## Lions Gate Phase 2

## REZONING Technical Data Sheet

Petition # 2004-147

SUBJECT: Administrative Approval for Petition No. 2004-147 by Crosland.

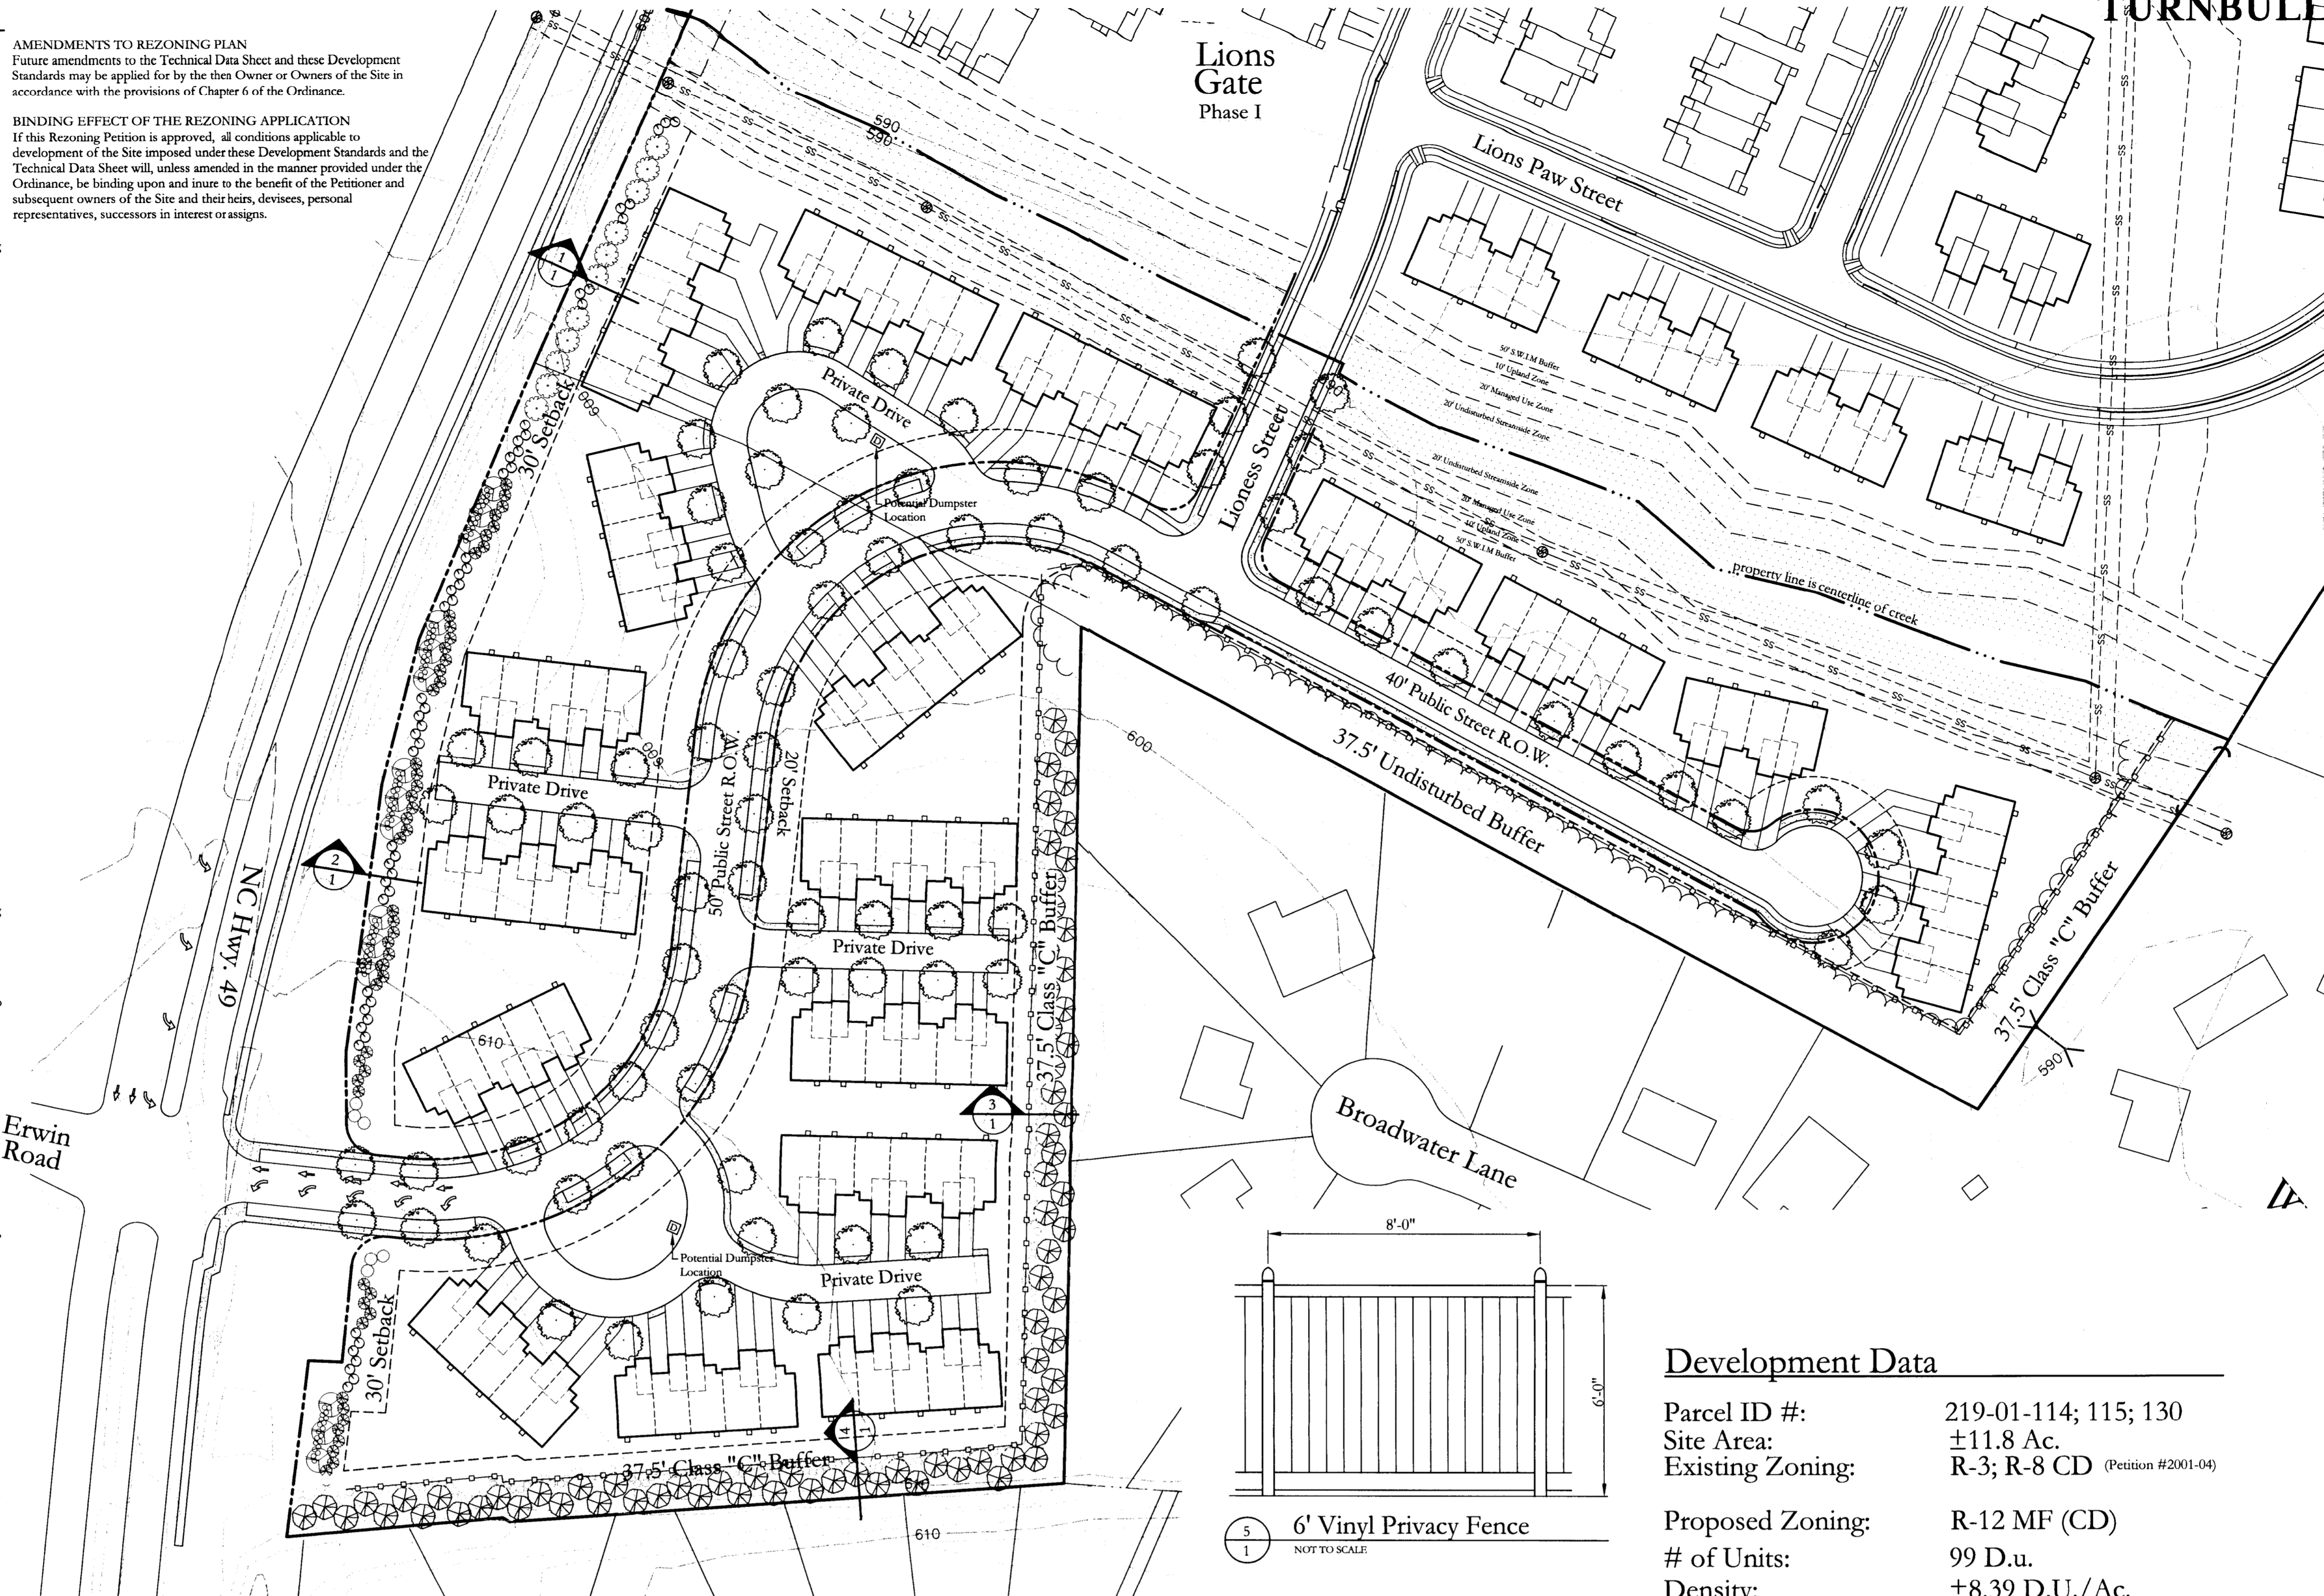
Attached is a revised plan for the above petition. The plan has been revised to change the storm water notes as requested by the Engineering Department. Since these changes do not alter the intent of the development and are minor, I am administratively approving this revised plan. Please use this revised plan when evaluating requests for building permits and certificates of occupancy.  
**Note that all other ordinance requirements still apply.**

- The Petitioner shall provide stormwater quality treatment of run-off generated from this development with the following conditions and allowances:
  - Treatment facilities are to be designed in accordance with the State of North Carolina Department of Environment and Natural Resources (NCDENR) Stormwater BMP Manual, April 1999.

- In lieu of BMP's in the State manual, treatment facilities may employ the use of proprietary, manufactured BMP systems provided:
    - Charlotte Stormwater Services has the need for monitoring data on the proprietary BMP's proposed

- Charlotte Stormwater Services approves the application of those manufactured BMP's as shown on the design plan.
    - Charlotte Stormwater Services has an agreement with the petitioner for the monitoring and access to study these facilities. If allowed the petitioner will establish with the City of Charlotte their respective scope and responsibilities with regard to the maintenance, monitoring and testing of the proprietary BMP's in a joint, written agreement that will be executed prior to plan approval.

- Run-off from portions of buildings adjacent to Pulk Ditch may be allowed to occur untreated by the above NCDENR or proprietary treatment facilities.

- A maintenance plan shall be developed to ensure adequate long-term operation of the structural stormwater treatment systems. This maintenance plan will be per NCDENR standards or per manufacturers specifications should they be used.
